William States Lee III Nuclear Station

COL Application

Technical Specifications

Revision 1

Figure 4.1-1

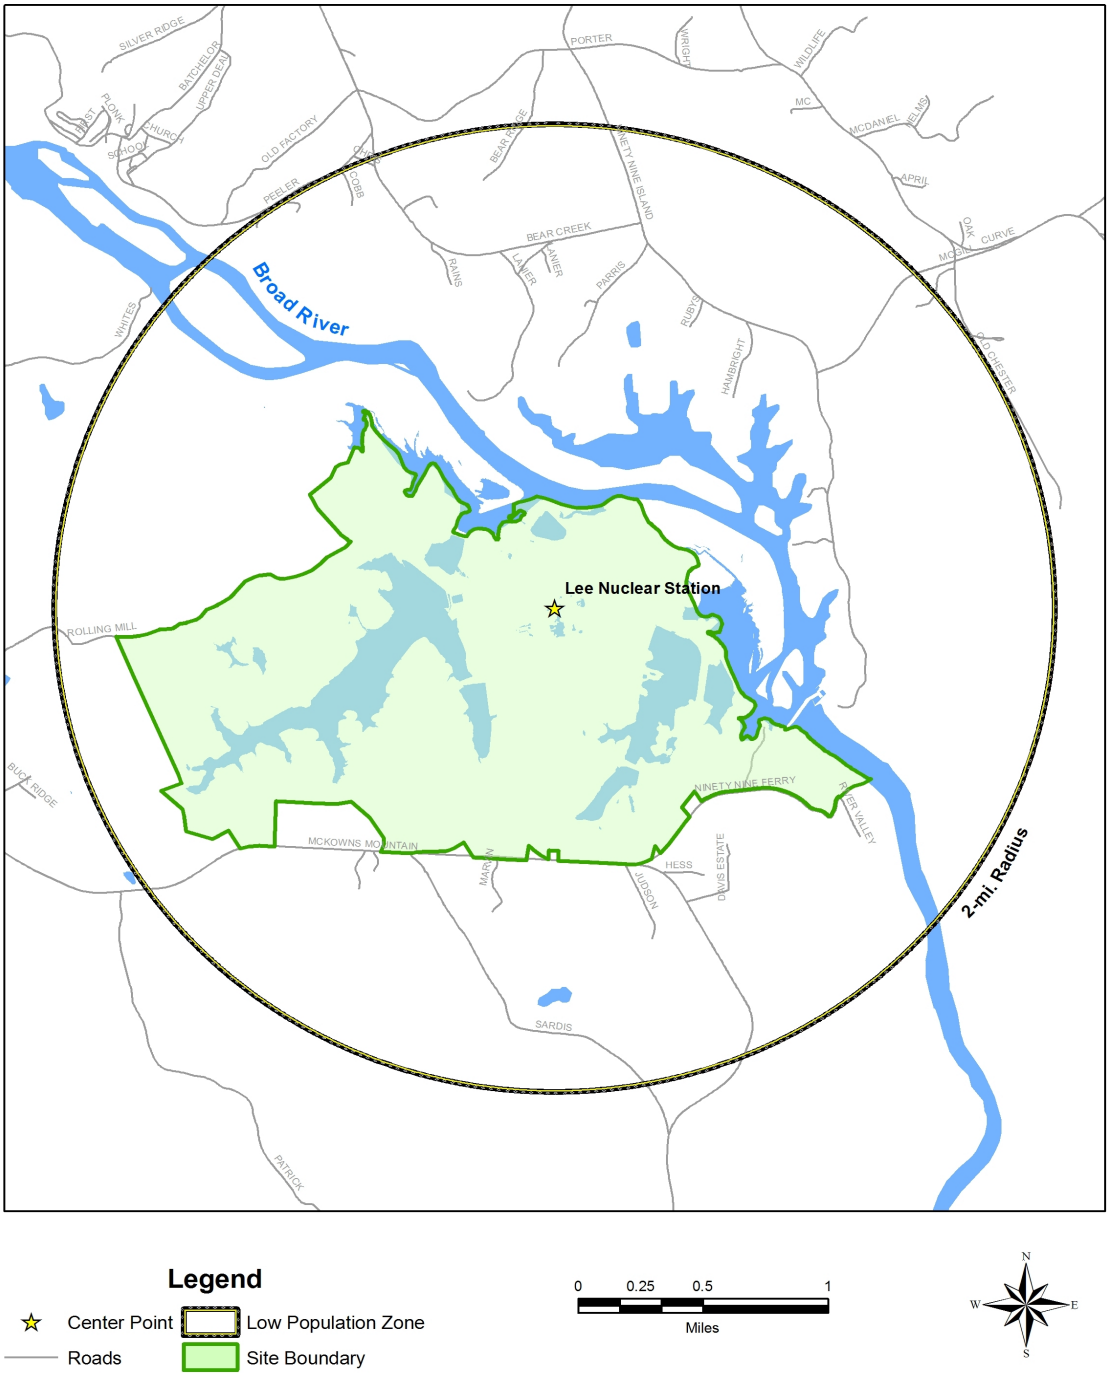
Replace the bracketed information in the GTS with the following:
The Site Boundary is shown in Figure 4.1-1. The Exclusion Area Boundary is shown in Figure 4.1-2.

Replace the bracketed information in the GTS with the following:
The LPZ is defined by the 2 mile radius from the site center point as shown in Figure 4.1-1.
